Re: Challenge and Appeal  
8 West 70<sup>th</sup> Street, Manhattan, Congregation Shearith Israel  
Proposed Condominium-Community House

On behalf of Nizam Kettaneh, Jay Greer, other interested parties, and myself, this letter constitutes a challenge and appeal to the determination of the DOB of May 4, 2015 approving the plans of Congregation Shearith Israel (“CSI” or “Congregation”) to construct a new condominium-community house building at 8 West 70th Street, Manhattan. BIS-32.<sup>1</sup> The challenge period is open until June 18, 2015. BIS-36.

The relevant Zoning Resolutions are 24-67, 23-633, 24-36, 23-633, 23-663, 24-11/77-24. The BIS Job Number is 121328919 and the Bin Document Number is Bin 1028510. This is an initial challenge to the DOB.

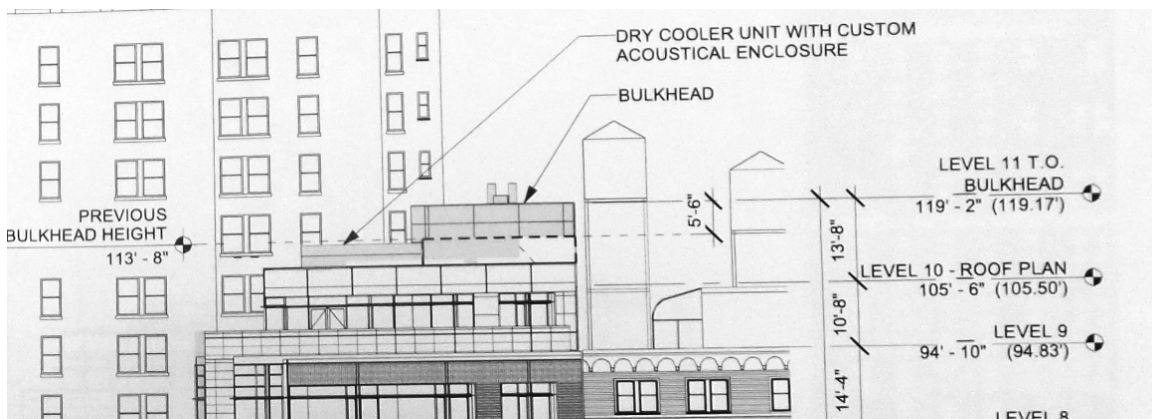
H. In 2013, when CSI finally applied for a construction approval, it filed a “PWIA: Schedule A- Occupancy/Use” form. BIS-21-BIS-25. In 2013, CSI in its PWIA showed a sub-sub-basement Banquet Hall (340 Persons) and on Floor 1, a Community Facility (305 persons) - and now apparently only one classroom on Floor 2, classrooms (for only 60 persons) and other uses on Floor 3, and NO classrooms on Floor 4. BIS-21, BIS-22, BIS-23. The 2013 PWIA did not show a caretaker’s apartment. Thus, CSI had virtually eliminated the facilities
